Official Recall Notification U.S. Federal Boat Safety Act—Possible Chafing of Orange Alternator Wire on 5.0L/5.7L/6.2L MPI Engines

On engine—Incorrect routing

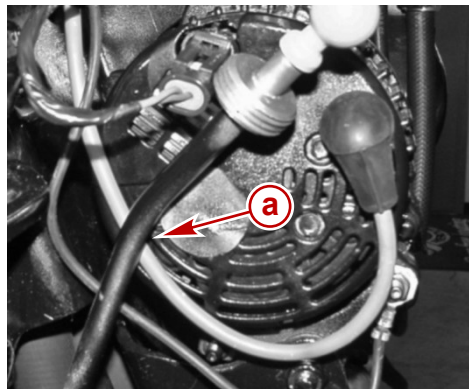
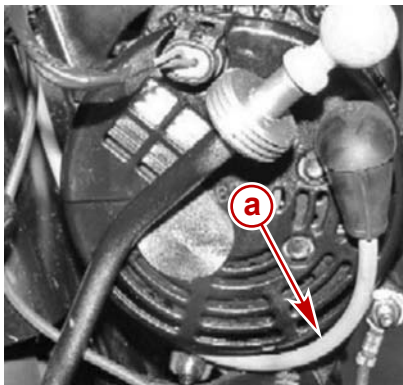
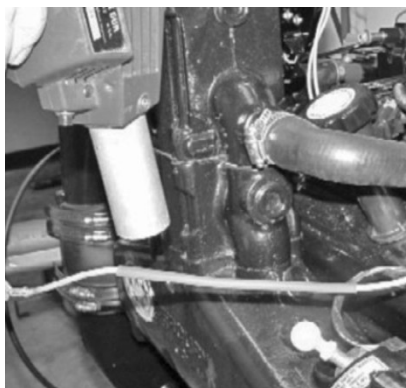
The incorrect routing places the orange alternator wire between the oil dipstick tube and the alternator. With that incorrect routing, it is possible that the insulating material will be chafed by the dipstick tube or the alternator, which could cause the wire to fail. If the wire fails, it could become an ignition source. See the "incorrect routing" photographs below.

a - Wire pinched by dipstick tube

a - Wire pinched by dipstick tube

The correct routing passes the orange alternator wire beneath the alternator, not in contact with the dipstick tube, which eliminates the opportunity for chafing and failure identified above. See the "correct routing" photograph following.

2. a. If the orange alternator wire is found to be free of evidence of damage caused by denting, rubbing, or chafing, route the wire under the alternator as shown below. No further action is required.

On engine—Correct routing (exhaust manifold removed for clarity)
